Report to the Future Melbourne (Planning) Committee

**Ministerial Planning Referral: TPM-2019-5
683-699 Elizabeth Street, Melbourne**

5 May 2020

MINISTERIAL PLANNING REFERRAL

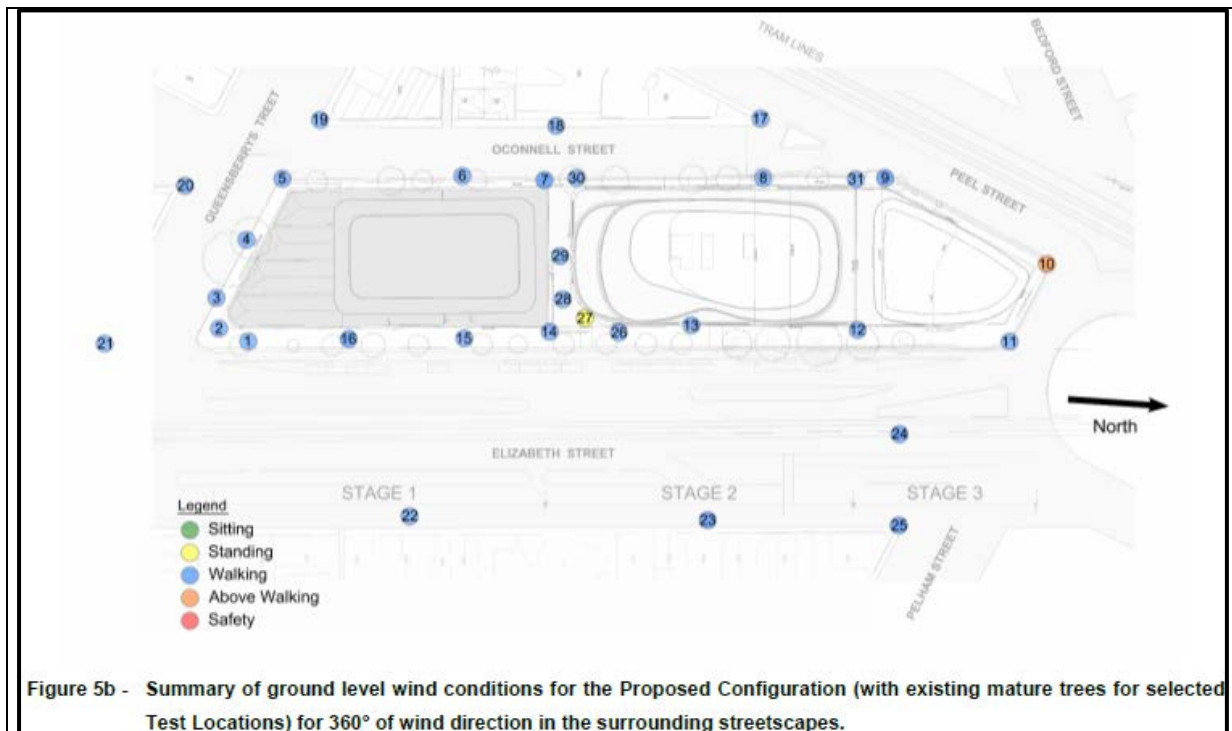
The Wind Impact Assessment prepared by MEL Consultants on the basis of the revised drawings accompanying the S.50 Amended Application (dated 15 July 2019) identify that at the ground level of all test locations surrounding the development, with the exception of a test location at the intersection of Peel Street and the Haymarket roundabout, have been shown to achieve the walking comfort criterion.

It is noted that MEL Consultants wind model testing has been performed on the basis of existing mature trees being retained in 'selected test locations'. These test locations are not clearly shown on the diagrams provided in the report identifying the tested wind speed comfort levels.

It is not appropriate to rely on landscaping within the public realm for the purpose of wind impact analysis, particularly where existing street trees may need to be pruned and / or removed to facilitate future aspects of the development.
